Official Transcript of Proceedings  
NUCLEAR REGULATORY COMMISSION

Title: Advisory Committee on Reactor Safeguards  
APWR Subcommittee - Open Session

Date: Friday, April 22, 2011

APWR SUBCOMMITTEE

# LWMS Process Flow Diagram (Chemical Drain and Detergent Drain Subsystems)

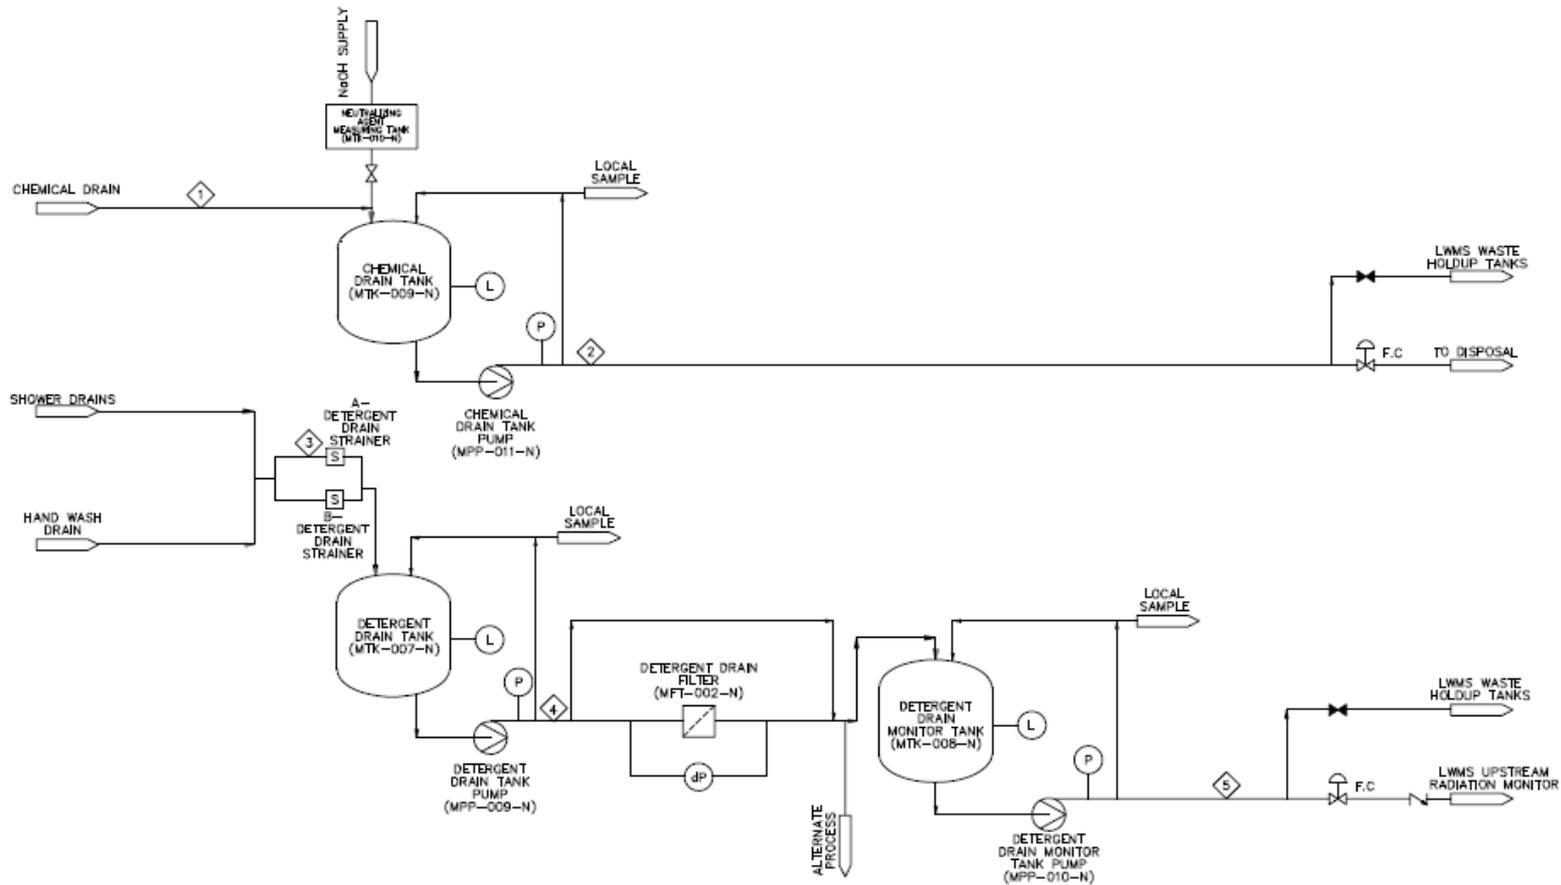
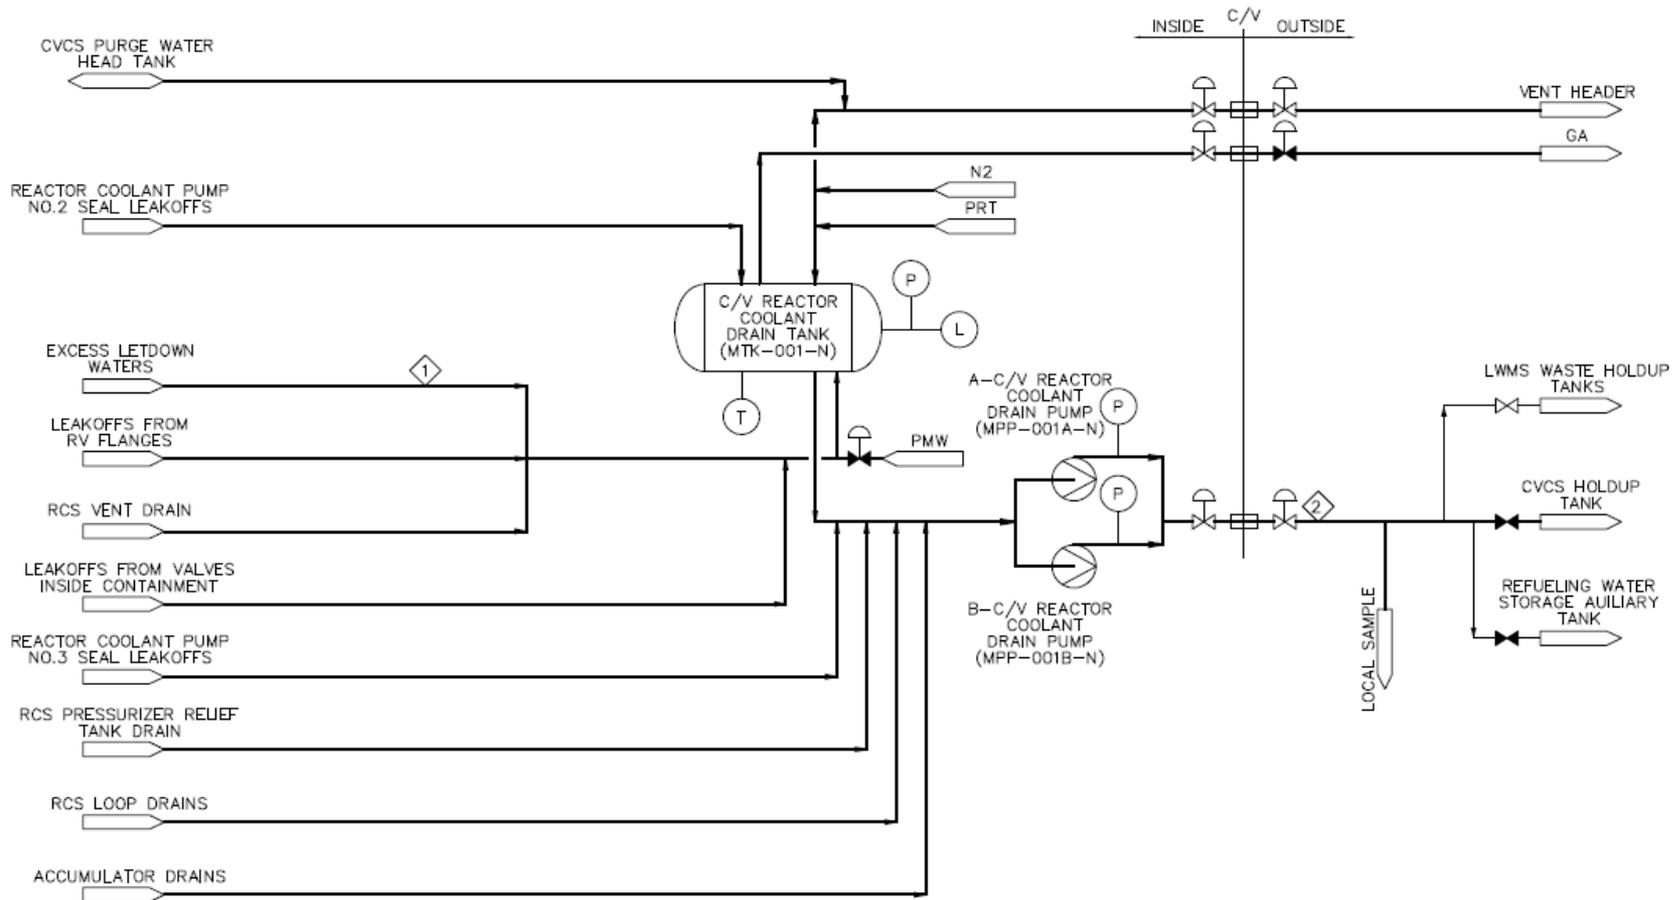
1 and, as Mike mentioned, whether you want to call it  
2 surge capacity or buffer capacity in case you have  
3 problems, is comparable to that installed in currently  
4 operating plants?

9 CHAIR STETKAR: Because I was curious about  
10 the actual operating experience. Many years ago I  
11 worked in a plant that was either under-designed or  
12 under-sized or whatever the problem was. We had a  
13 habitual problem with water management because of our  
14 -- our throughput processing capability in actuality,  
15 was not nearly what the designers had planned for.

13 In other words, how frequently will you  
14 need to take a demineralizer string down for either  
15 resin regeneration or if you're just going to remove  
16 the resin and replace it. I don't know, you know, how  
17 you're going to manage the resins because that can  
18 contribute to downtime, you know, on your throughput.

6 A lot of plants still do have radwaste  
7 evaporators. So, is the maximum experience from  
8 plants that use a full demineralize-based liquid waste  
9 processing system?

15 Does the four containers per year  
16 experience come from plants that do not have  
17 evaporators that use pure demineralized liquid waste  
18 processing system for all liquid waste drains?

23 CHAIR STETKAR: Yes, that would be a little  
24 bit relevant, you know. If the four containers per  
25 year comes from plants that have a pure demineralize-

23 Next, please. On this slide, I'd like to  
24 take this opportunity to answer your question. Number  
25 1 is that the technology presented here are all

18 MR. TSANG: I'd like to add a couple of  
19 comments to further explain what we have done.

20 And of course we need to allocate time for  
21 mixings, for sampling, all these activities and  
22 confirmation sampling after this treatment. And all  
23 these we anticipate with the current design and  
24 technology and equipment available at the plant,  
25 probably in a day and a half we could finish one tank.

21          MR. TSANG: And I would say I don't have a  
22 factor of five compared to the existing plant, but a  
23 factor of two can easily be achieved.

19 MR. TSANG: I need to take that question  
20 back. The database that we have talking to utilities  
21 covers about 25, 30 plants. And I do not remember  
22 whether each plant would have a radwaste -

4 MR. TSANG: I will take that question and  
5 provide a response later.

# GWMS Process Flow Diagram

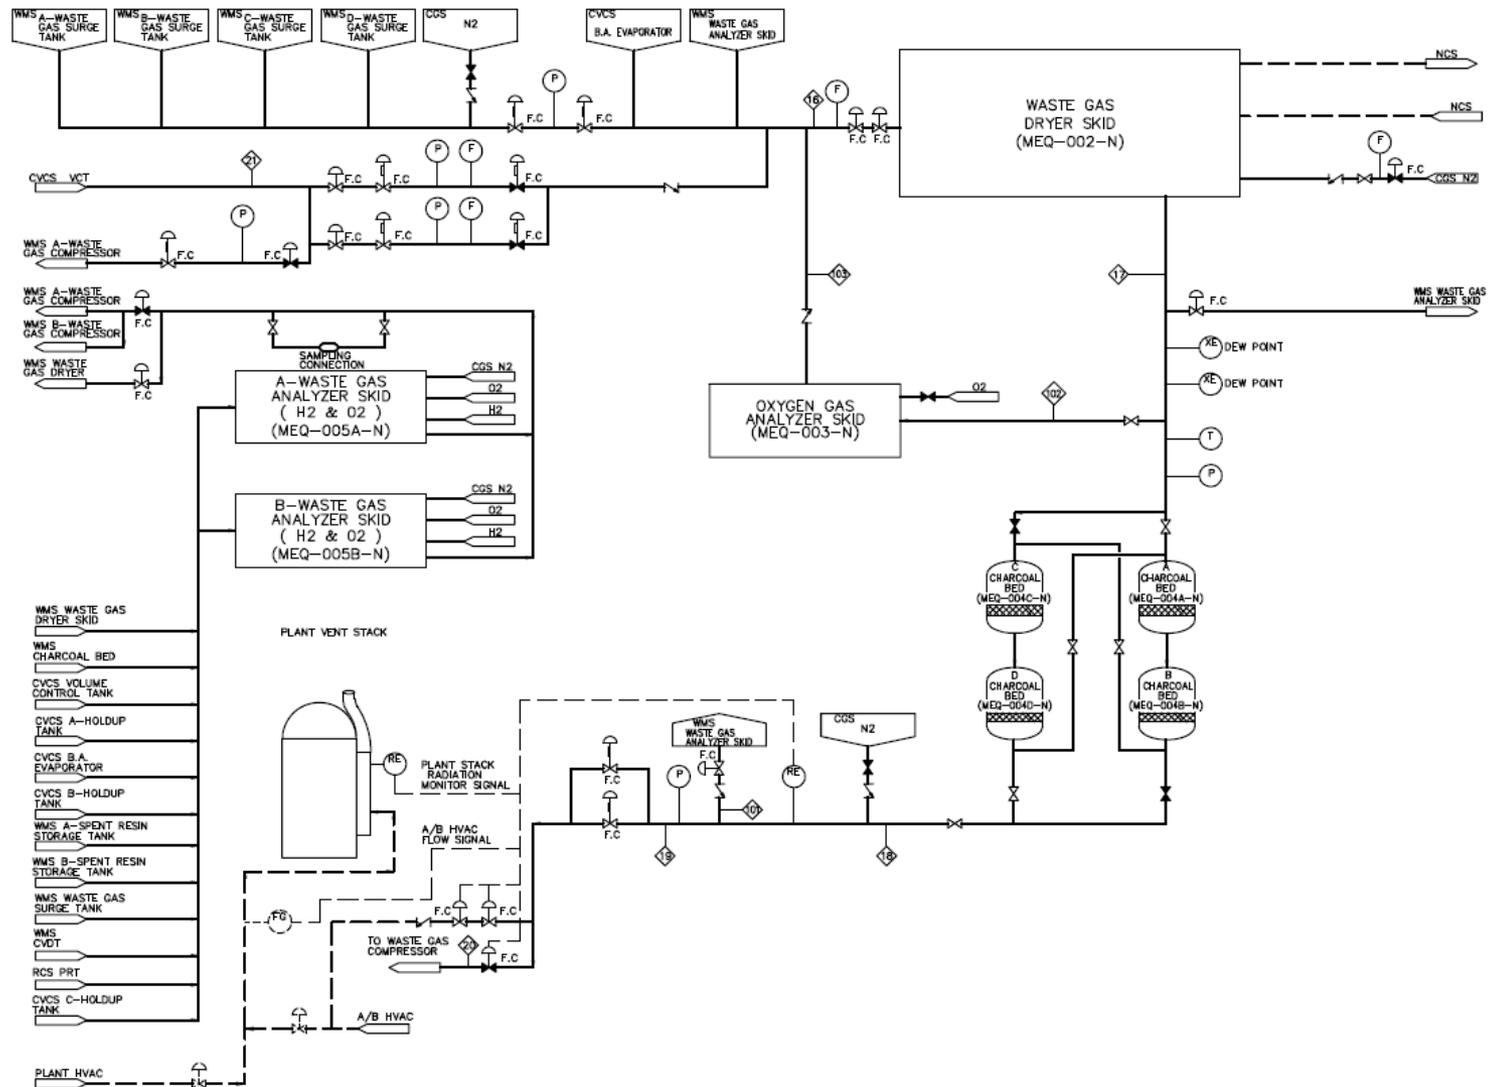
8 MEMBER BROWN: Excuse me just a minute.  
9 Correct me if I'm wrong. It seems all these, the vent  
10 stack is common for all the standard HVAC, as well as  
11 the gaseous waste discharge as well? And they all  
12 come together in one point like that.

21 The question I had is are those operator  
22 actions - where is this system controlled from? Is it  
23 from a local operator station in the auxiliary  
24 building or is it from the main control room?

16 The reason I ask the question is if you're  
17 relying on operator actions to mitigate the  
18 consequences of what might be a hydrogen explosion and  
19 a fire, I would hope that the operator is in a  
20 location that's protected from those possible  
21 consequences.

21 The reason I ask that, at the plant that  
22 I was mentioning, it didn't. I don't need to go into  
23 details of how we did it, but they were not directly  
24 processed through anything that you show on this  
25 slide. So, I was curious where those lines actually

9 CHAIR STETKAR: Because there were  
10 questions about, you know, the presumed amount of  
11 noble gases versus the time after shutdown that you'd  
12 be doing the gaseous - the gassing operation as a  
13 basis for the amount of releases from a tank failure  
14 in the gaseous waste processing system.

15 That's sort of what prompted my question  
16 about how the thing was actually piped together.

1 this question back and we analyze the design and get  
2 back to you.

7 MR. TSANG: I'd like to take that question  
8 back.

4 MR. TSANG: Very good, sir. We will answer  
5 that.
